Executive Director's Recommendation

Commission Meeting: October 1, 2020

PROJECT Pentagon Reservation Stormwater Management Design and Security Upgrades Pentagon Reservation 1 Pentagon Access Road Arlington, Virginia	NCPC FILE NUMBER 8215
SUBMITTED BY United States Department of Defense Washington Headquarters Services	NCPC MAP FILE NUMBER 1.62(38.00)45201
REVIEW AUTHORITY Federal Projects in the Environs per 40 U.S.C. § 8722(b)(1)	APPLICANT'S REQUEST Approval of comments on concept plans
	PROPOSED ACTION Approve comments on concept plans
	ACTION ITEM TYPE Staff Presentation

Overall Project Layout Axonometric

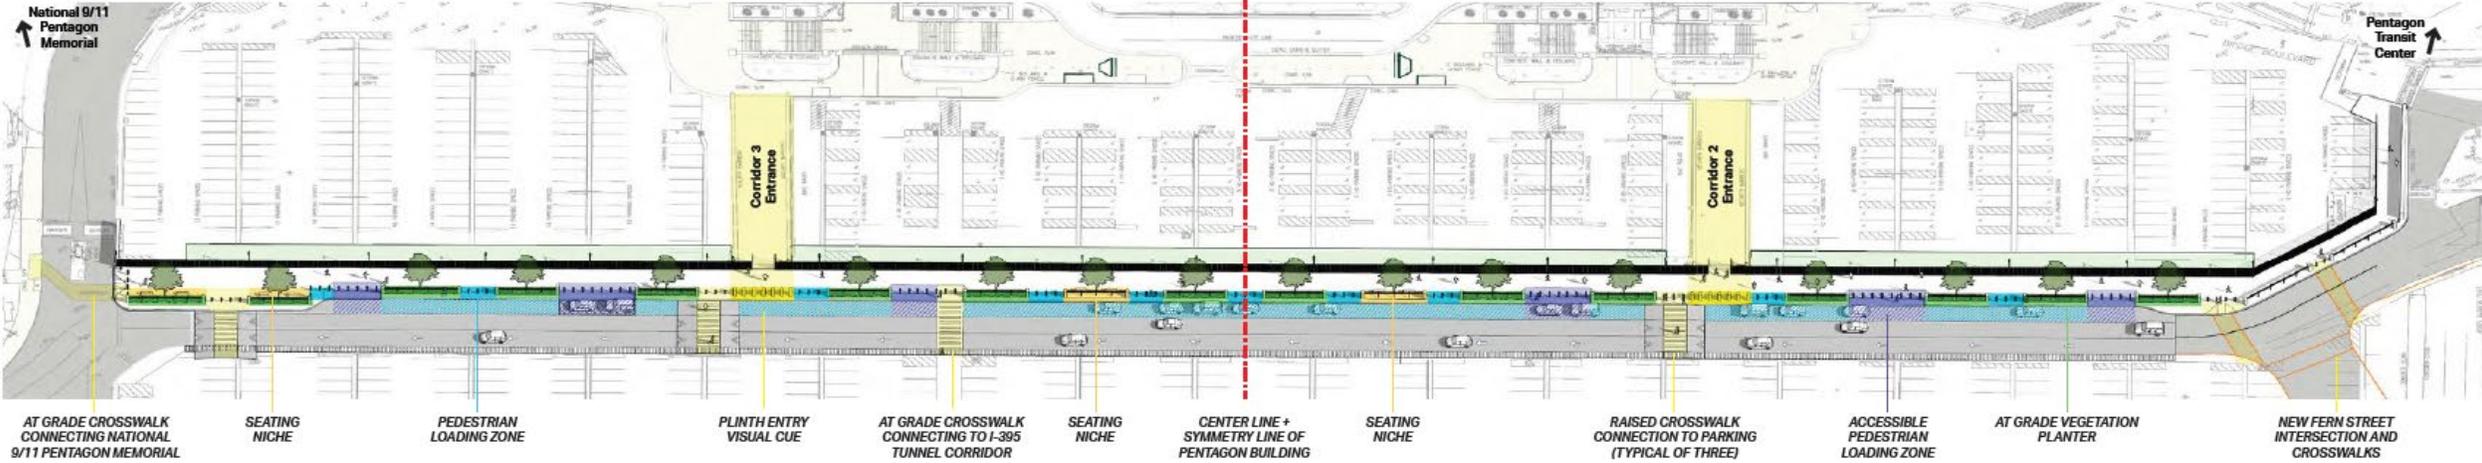
Finds the Project 6 concept design is still not a very welcoming pedestrian experience for visitors and employees as it will be located between two new perimeter security elements, a new eight-foot-tall fence on one side and bollards and cable rail system on the other. Therefore, staff **requests** the applicant explain why the fence line needs to be at this location and why it cannot be relocated closer to the Pentagon or combined with the bollard/cable rail system. This explanation should include how the project aligns with the master plan and the location of perimeter security needed for buildings, vehicles, and pedestrians in addition to existing constraints on the site (such as grade changes).

- Reducing the monotony of the 1200-foot-long fence with planting strips /low shrubs and repeating fence posts/pillars.
- Widening the entrances to Corridors 2 and 3.
- Reducing the scale of the large stone clad bollards at the employee entrance gates.
- Adding additional landscaping including trees given the size of the proposed planting areas.
- Improving the pedestrian realm with the incorporation of other pedestrian friendly items could improve the experience such as public art.
